AIR - LP COMPRESSOR BLEED, MASTER ACTUATOR - INTRODUCTION OF REVISED TORQUEMOTOR STRAINERS - CATEGORY CODE 6 - MOD.ENG-75-0076

V2500-ENG-75-0076

ENGINE COMPRESSOR CONTROL - LPC BLEED MASTER ACTUATOR INTRODUCTION OF TORQUE MOTOR WITH REVISED FILTRATION TO PREVENT BLOCKAGE WITH FUEL DEGRADATION PRODUCTS

(LUCAS AEROSPACE MOD. D.TV.060)

LPC Bleed Master Actuator Identification
Figure 1

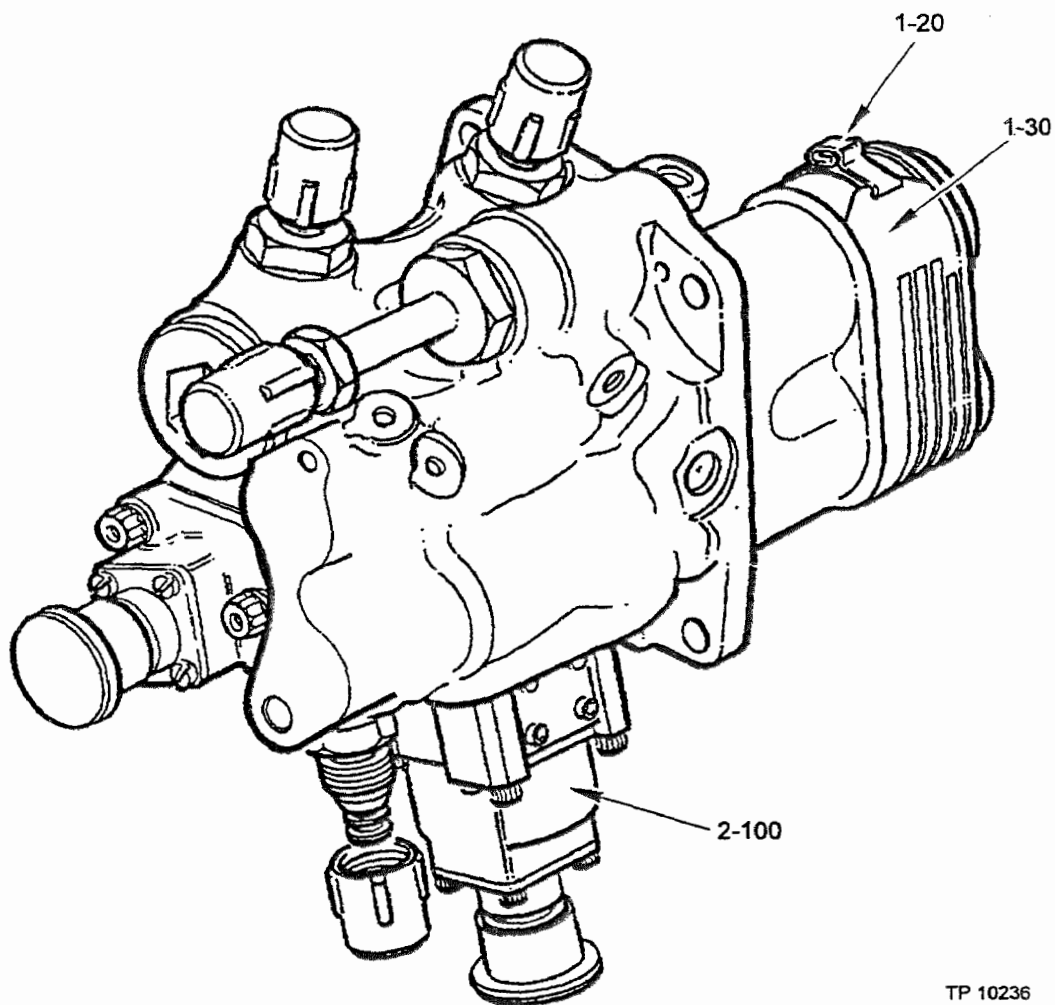
The current standard of Torque Motor (in the Master L.P.C. Bleed Unit Actuator) is prone to blockage of the filters by fuel degradation products.

This Service Bulletin (Modification) introduces a Torque Motor with revised filtration to prevent blockage by fuel degradation products.

Install the Torque Motor in accordance with the Component Maintenance Manual. Existing Torque Motors can be reworked by the manufacturer (Moog Controls Ltd).

A. Replace the Torque Motor Pre SB 1666-75-005

(1) If the Torque Motor (2-100) part no. 1656-1054 is to be modified, remove it from the disassembled kit of parts and either:

— Send the torque motor for rework and install the modified unit, part number 1777-9000

- Install a previously modified unit, part number 1777-9000 or 1777-9001.

- (1) If the torque motor (2-100A) part no. 1727-4008 is to be modified, remove it from the disassembled kit of parts and either:
 - Send the torque motor for rework and install the modified unit, part number 1777-9001
 - Install a previously modified unit, part number 1777-9001.

- (1) Put the new identification plate (1-30) part number 215-4009 on a flat surface. Mark the identification plate with 1.60 mm (1/16in) letter/number stamps:

- (2) Fill the stamped letters and numbers with black paint and wipe away the surplus.
- (3) Install the new identification plate (1-30) part number 215-4009 on the unit with the new strap (1-20) part number 215-410.

LPC Bleed Master Actuator Identification

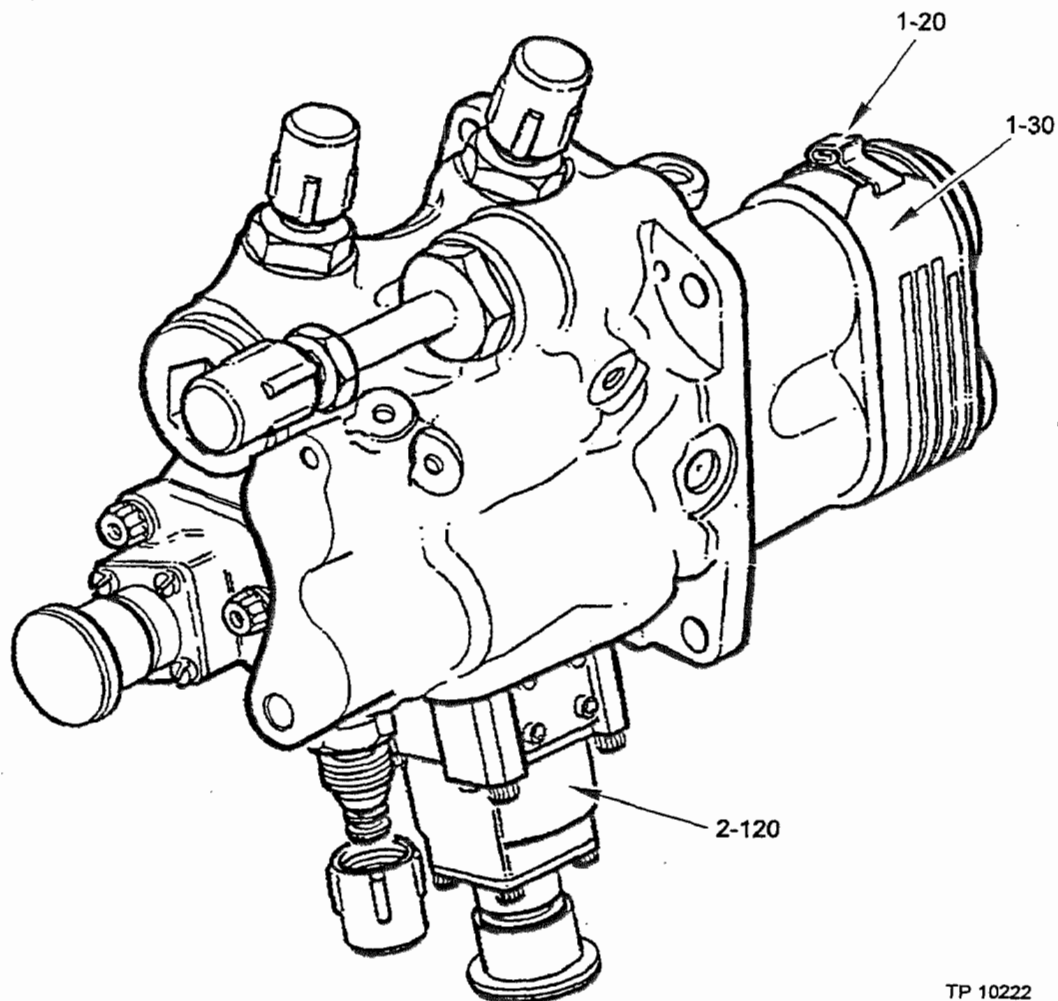
The current standard of Torque Motor (in the Master L.P.C Bleed Unit Actuator) is prone to blockage of the filters by fuel degradation products.

This Service Bulletin (Modification) introduces a Torque Motor with revised filtration to prevent blockage by fuel degradation products.

Install the Torque Motor in accordance with the Component Maintenance Manual. Existing Torque Motors can be reworked by the manufacturer (Moog Controls Ltd).

A. Replace the Torque Motor Pre SB 1777-75-001

(1) If the torque motor (2-120) part no. 1656-1054 is to be modified, remove it from the disassembled kit of parts and either:

— Send the torque motor for rework and install the modified unit, part number 1777-9000

- Install a previously modified unit, part number 1777-9000 or 1777-9001.

- (1) If the torque motor (2-120A) part no. 1727-4008 is to be modified, remove it from the disassembled kit of parts and either:
 - Send the torque motor for rework and install the modified unit, part number 1777-9001
 - Install a previously modified unit, part number 1777-9001.

- (1) Put the new identification plate (1-30) part no. 215-4009 on a flat surface. Mark the identification plate with 1.60 mm (1/16in) letter/number stamps:

- (3) Install the new identification plate on the unit with the new strap (1-20) part no. 215-410.

LPC Bleed Master Actuator Identification
Figure 1

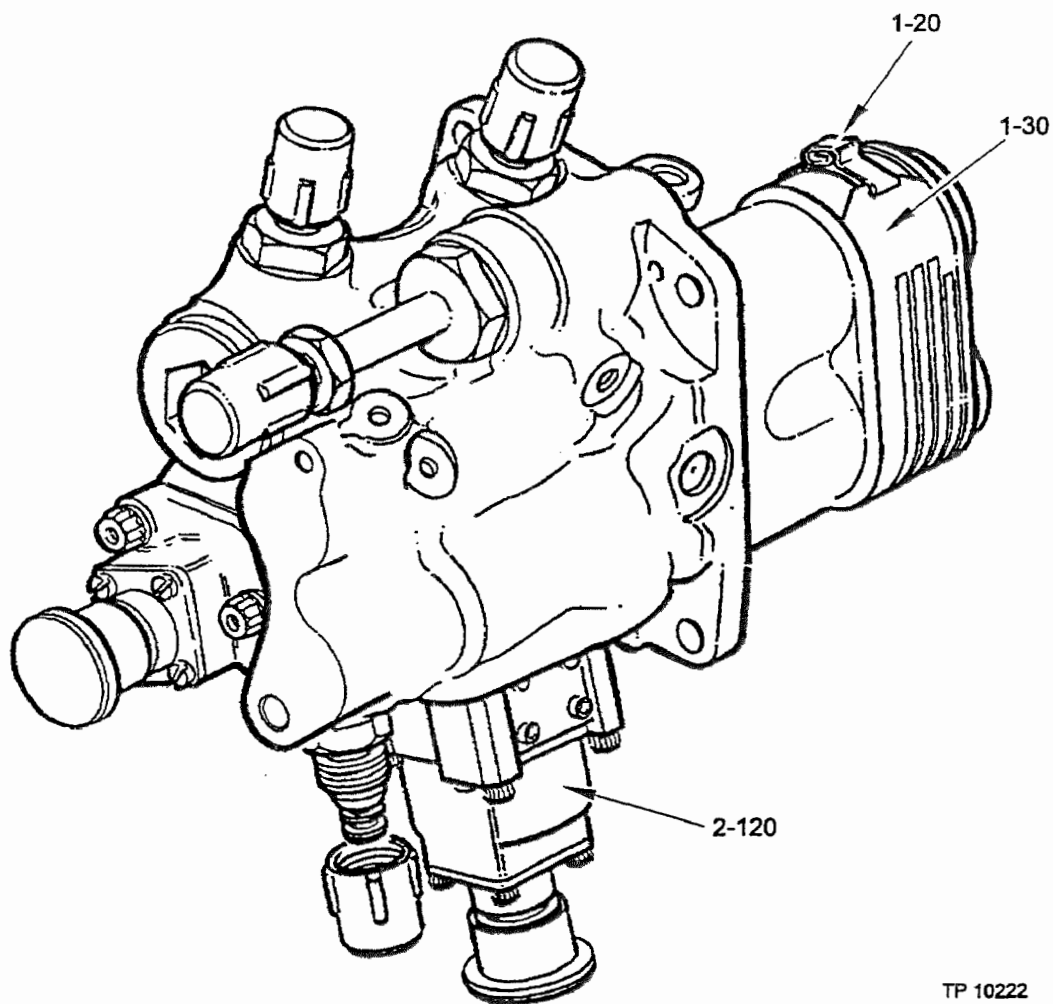
The current standard of Torque Motor (in the Master L.P.C Bleed Unit Actuator) is prone to blockage of the filters by fuel degradation products.

This Service Bulletin (Modification) introduces a Torque Motor with revised filtration to prevent blockage by fuel degradation products.

Install the Torque Motor in accordance with the Component Maintenance Manual. Existing Torque Motors can be reworked by the manufacturer (Moog Controls Ltd).

A. Replace the Torque Motor Pre SB 1797-75-002

(1) If the torque motor (2-120) part no. 1767-4001 is to be modified, remove it from the disassembled kit of parts and either:

— Send the torque motor for rework and install the modified unit, part number 1797-9000

— Install a previously modified unit, part number 1797-9000.

- (1) Put the new identification plate (1-30) part no. 215-4009 on a flat surface. Mark the identification plate with 1.60 mm (1/16in) letter/number stamps:

- (2) Fill the stamped letters and numbers with black paint and wipe away the surplus.
- (3) Install the new identification plate (1-30) on the unit with the new strap (1-20) part no. 215-410.
